Access Compliance Report

Public Rights-of-Way

(Curb Ramps)

Intersection ID: N/A	Main Street: WOODRIVER_LN	Cross Street: DOWINGTON_DR	Location: SE
ADA ID: 9BAF594DB56B	Ramp Type: Perp	Initial Pass/Fail: Fail	Overall Compliance: No
Severity Score: 33.75			
Codes/Mitigation Info/Possible Solution		Field Measurements/Component Compliance

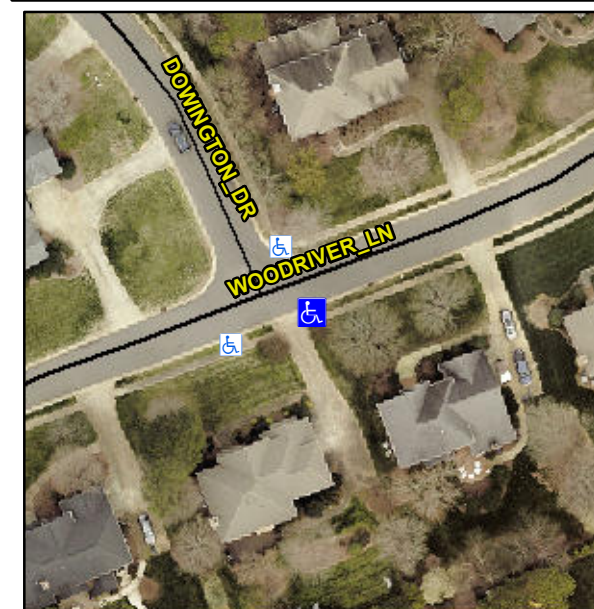
R304.5.1, R304.5.3

Compliance	Description	Data	Compliance	Description	Data
N/A	Ramp Length (in)	96.0	Yes	Ramp Slope (%)	6.1
No	Ramp Width (in)	46.0	No	Ramp XSlope (%)	9.3
N/A	Flare Type LT	N/A	N/A	Flare Type RT	N/A
N/A	Flare Slope LT (%)	N/A	N/A	Flare Slope RT (%)	N/A
N/A	Flare Traversable LT?	N/A	N/A	Flare Traversable RT?	N/A
N/A	Landing Length (in)	N/A	N/A	DWS Provided?	N/A
N/A	Landing Width (in)	N/A	N/A	DWS Contrast?	N/A
N/A	Landing Slope (%)	N/A	N/A	DWS Length (in)	N/A
N/A	Landing X Slope (%)	N/A	N/A	DWS Full Width?	N/A
N/A	Landing Curb? (Y/N)	N/A	N/A	DWS Offset (in)	N/A
N/A	Shared Landing?	N/A			
N/A	Gutter Ponding?	N/A	N/A	Gutter Slope (%)	N/A
N/A	Gutter Lip Ht (in)	N/A	N/A	Gutter X Slope (%)	N/A
N/A	Painted X Walk1?	No	N/A	Painted X Walk2?	N/A
	X Walk 1 Direction	To N		X Walk 2 Direction	N/A
N/A	X Walk 1 Width (in)	N/A	N/A	X Walk 2 Width (in)	N/A
	X Walk 1 Slope (%)	3.5		X Walk 2 Slope (%)	N/A
	X Walk 1 X Slope (%)	8.6		X Walk 2 X Slope (%)	N/A

Remove & Replace Entire Ramp.
